8.7. Marist Catholic College Major Project Application (Application SSD – 10473)

To highlight for Council's information planning issues arising from the Marist Brothers Catholic College State Significant Development application.

Artists Impression at Corner Miller and Carlow Streets

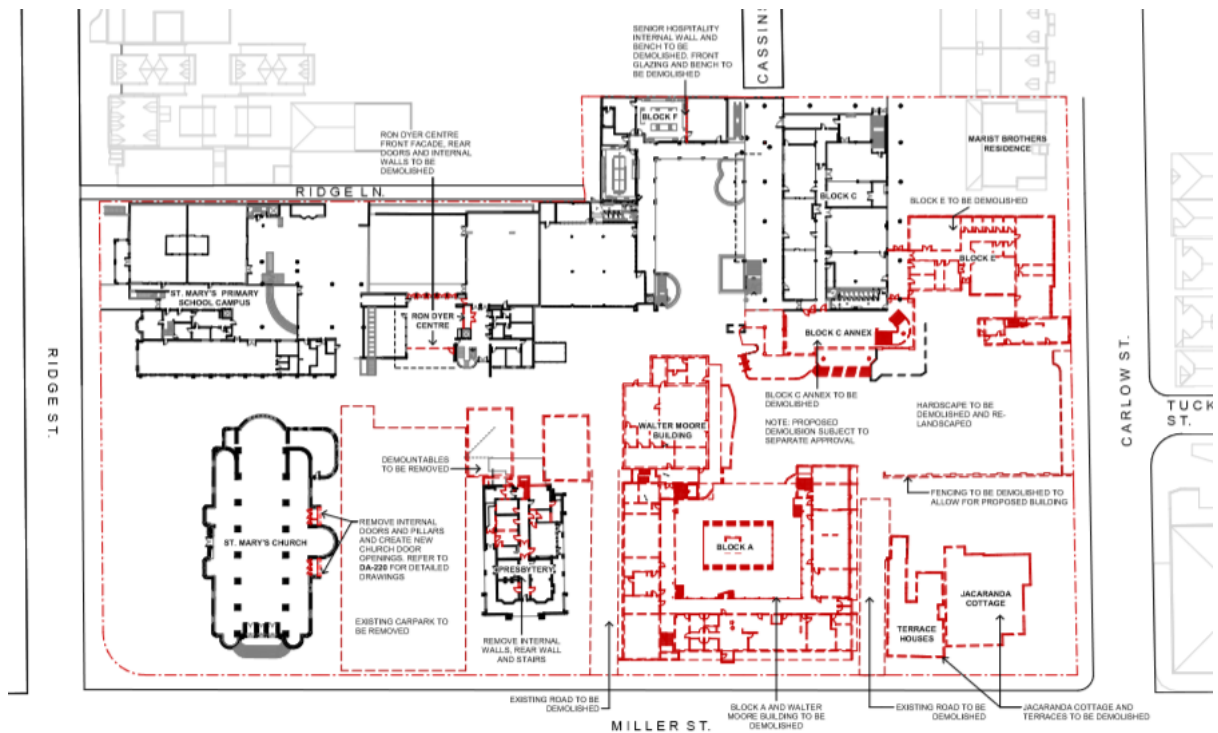
Having regard to the design principle the proposed four storey height along Miller Street and Carlow Street might not be considered to respond appropriately to the surrounding low-scale context, particularly as the height is concentrated around the perimeter of the site rather than in the centre. There is no stepping down of height towards at the edges of the site, which reinforces the monolithic form of the development.

The façade provides no substantial architectural breaks or articulation, resulting in a consistent building mass along the two street frontages. The building does not relate to the low scale residential further north along Miller Street and east along Carlow Street.

The proposal is designed to focus into the site rather than out. There may be some secondary interaction/glimpses into the undercroft play area from the intersection at Miller and Carlow Streets. A setback above the first or second floor is needed to break down the 'fence like' appearance of four storeys around that corner.

Consideration should be given to providing a variation in building height to provide a transition between the proposal and surrounding lower scale development.

The length of the development on the corner of Miller Street and Carlow Street should be broken up through physical breaks in the building façade.

Lower level of new buildings showing auditorium and parking. Vehicle exit/ entrance is at top right of the image onto Carlow Street.

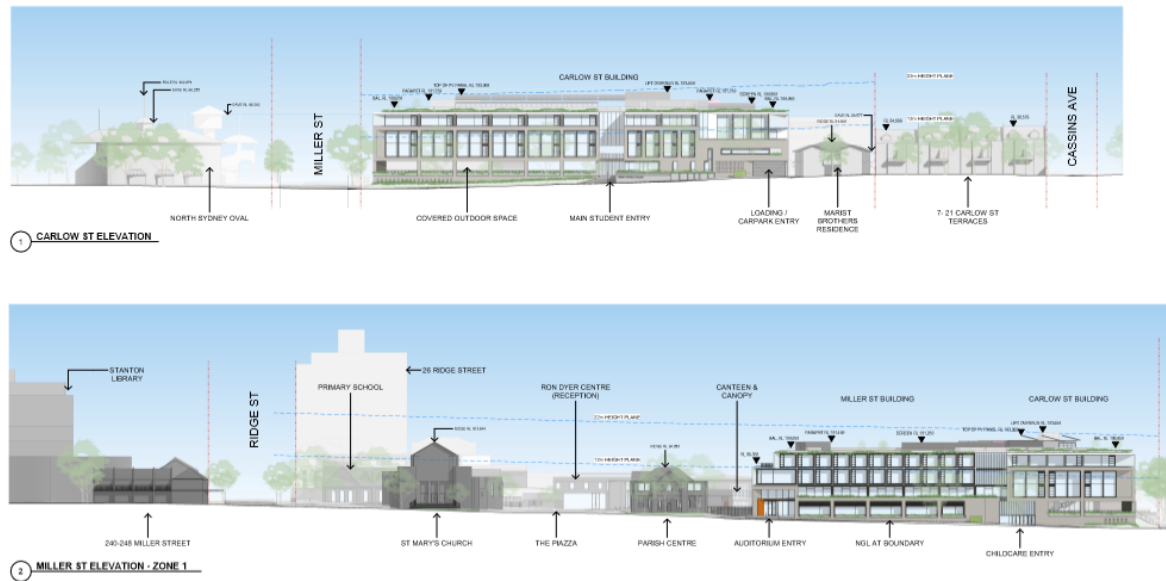
Basement carpark proposed. 2 existing driveways on Miller Street to be removed. New double driveway in Carlow Street proposed.

Significant excavation for basement parking adjacent to council property noted. Appropriate conditions will be recommended to address the above matters.
